Commission of Fine Arts

Revised Concept Presentation

UEPH Barracks

Joint Base Myer – Henderson Hall

West Elevation

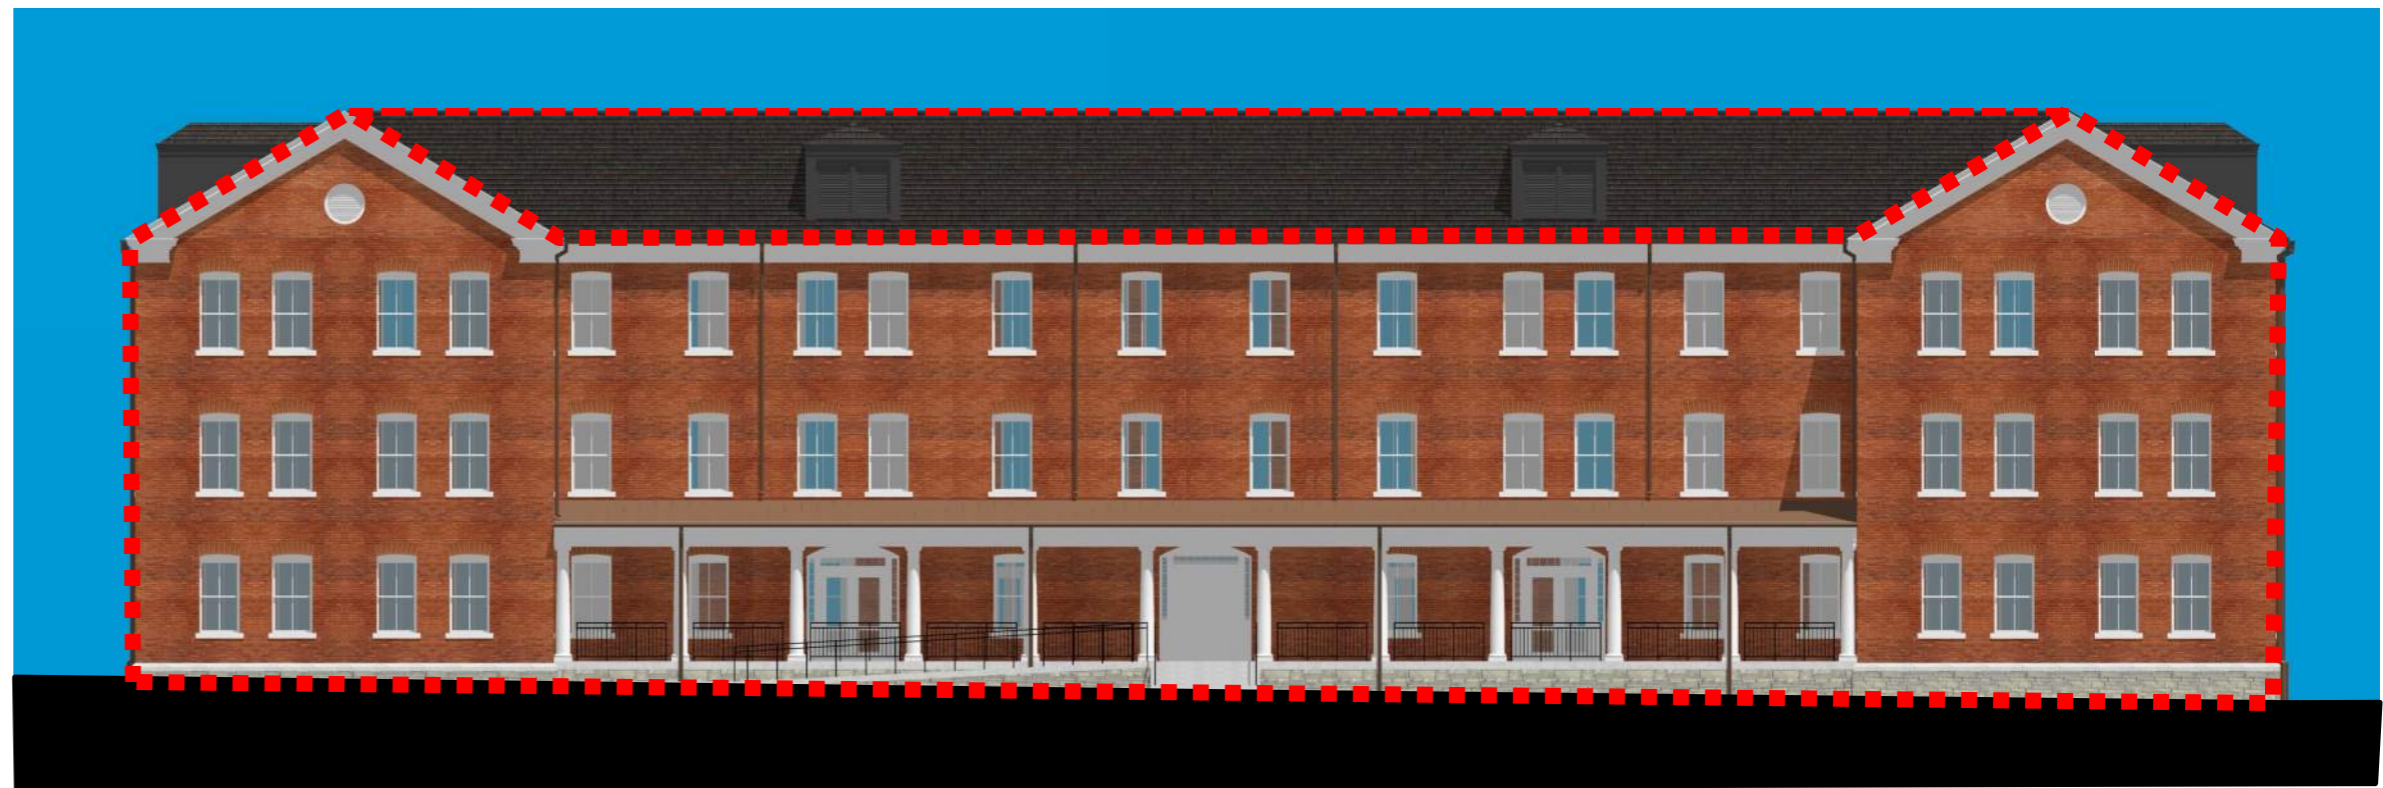
Scale, Height and Detail

The reduction in overall height includes:

- (1) Floor to floor height decreased approximately 1'-8" per floor;
- (2) The attic height has been reduced by narrowing the gables and introducing interstitial roof areas between the ridges;
- (3) The first-floor level in each building is closer to grade by approximately 1 foot.

The original submission elevation is the top image with the revised elevation below. The overall reduction in height is approximately 14 feet.

East Elevation

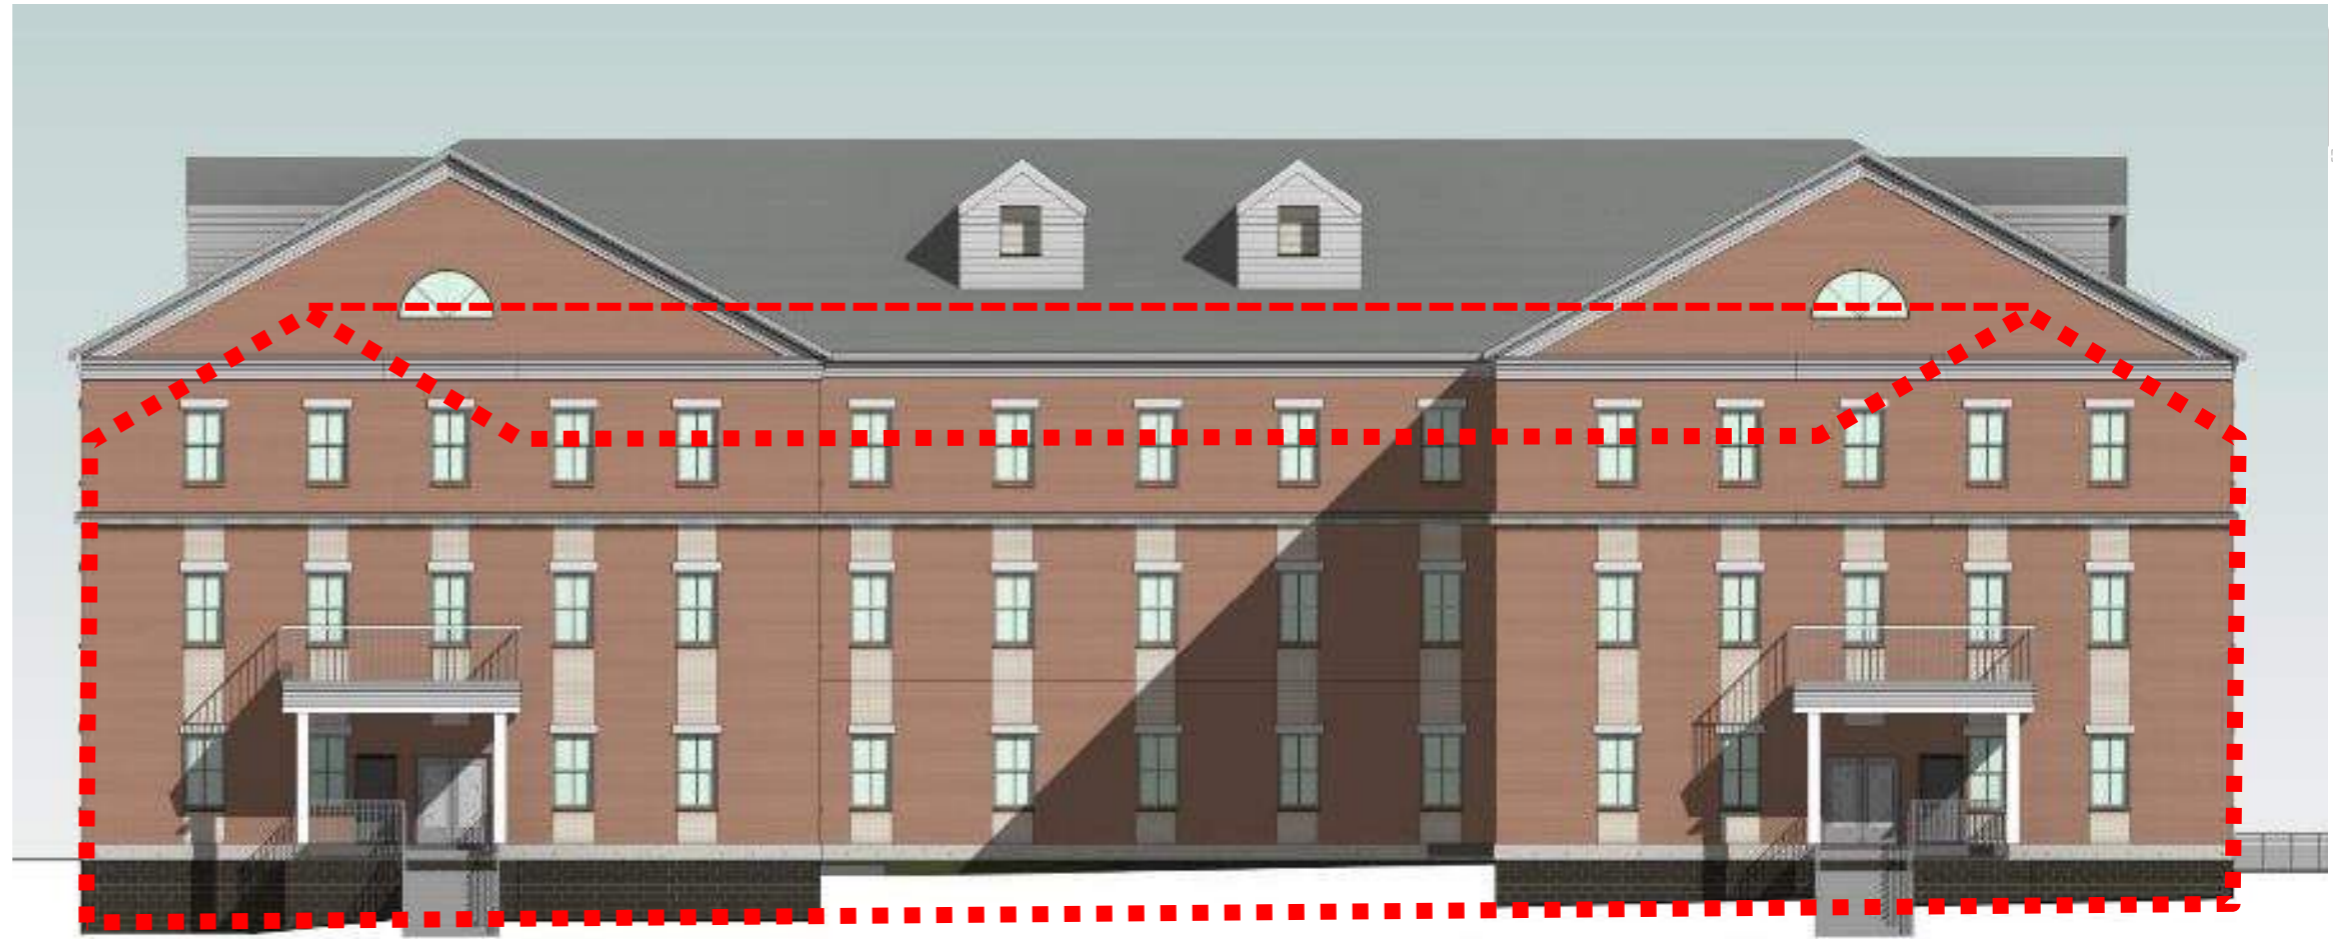
As illustrated in the pages that follow, in addition to scale and height, architectural changes include:

- Reportioned Windows
- Brick Arch Window Heads
- Dormer Color and Scale
- Reduced Gable Sizes
- Reportioned Porches
- Materials
